IloT Product Change Notice

4. Description of the Change(s):

6. Different Chassis Hole

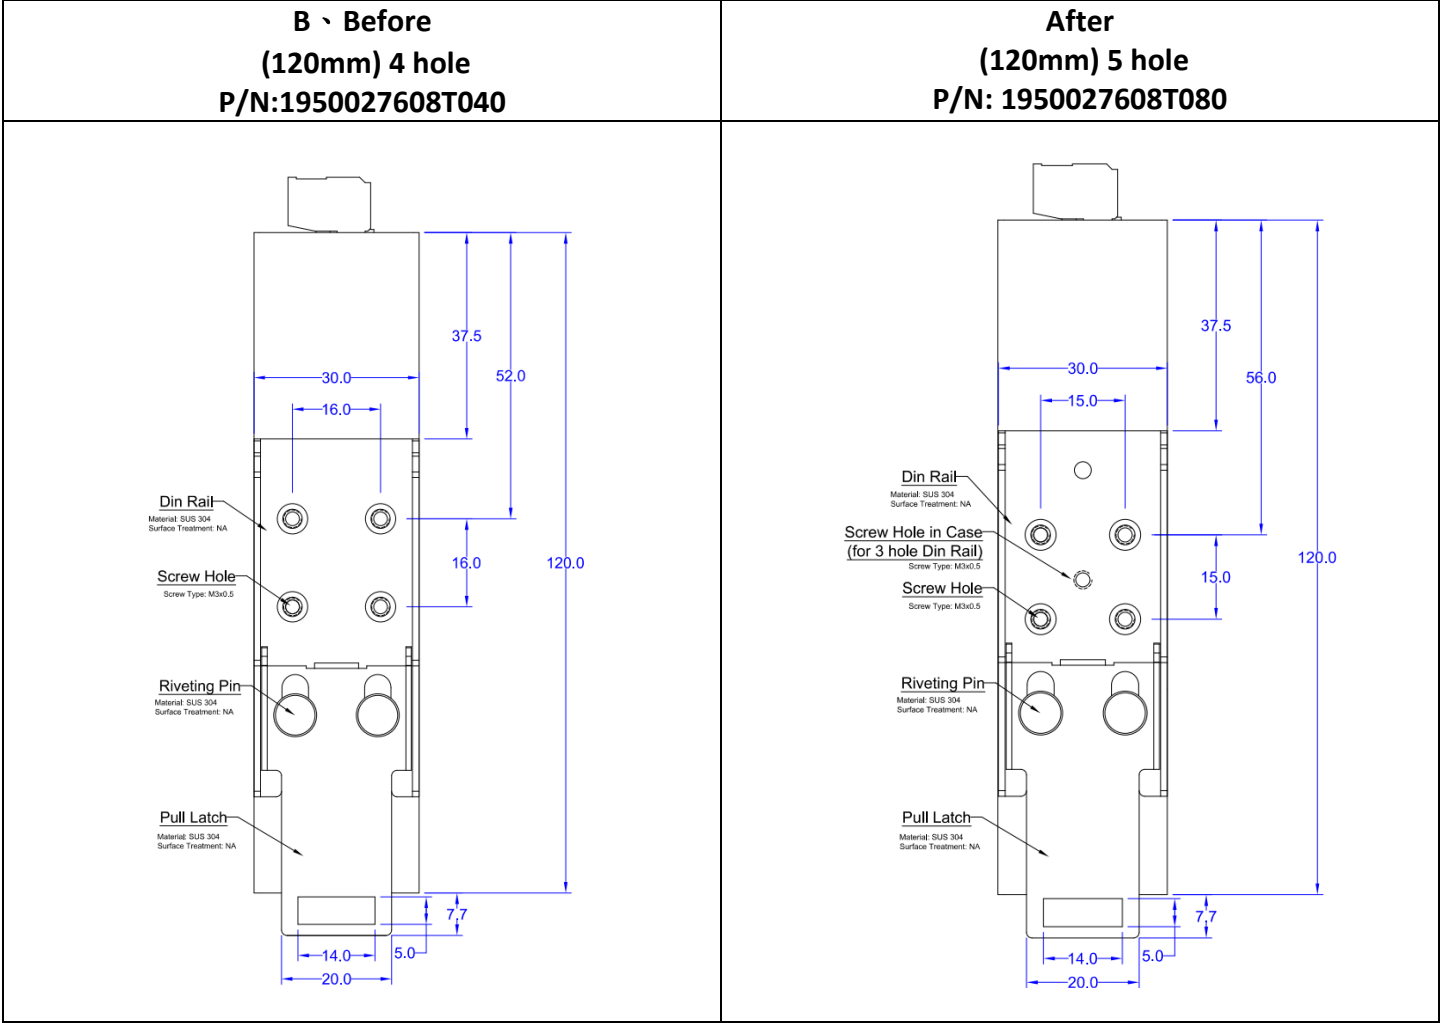
A 、 Before : (140mm) 4 hole P/N: 1950027608T030	After : (140mm) 5 hole P/N: 1950027608T070

B 、 Part No: EKI-2525NI-A
